See attached letters from Kansas Historical Society in review of suggestion to install a bathroom in nave of St. Mary's Church.

Re: Site Visit Report for St. Mary's Church, St. Benedict – Nemaha County

From: Ken Price, Agency Architect, Kansas Historical Society
Re: St. Mary's Church, St. Benedict September 30, 2011 Site Visit Follow-Up

**Plan-1C: 2010 Standards Minimum with
Out-Swinging Door**
(entry door has both closer and latch)

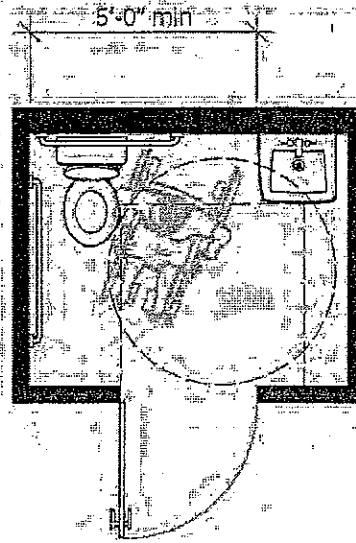
Also provided is a toilet room layout taken from the ADA 2010 Standards that represents the minimum layout for a handicap restroom.

This plan shows the same typical features of a single-user toilet room that meets the minimum requirements of the 2010 Standards as Plan-1B does except the entry door has both a closer and latch. Because the door has both a closer and latch, a minimum additional foot of maneuvering space is required on the latch side (see section 404.2.4.1 and Figure 404.2.4.1(c) of the 2010 Standards).

This layout is six point two percent (6.2%) larger than the accompanying Plan-1A: 1991 Standards Minimum with Out-Swinging Door example.
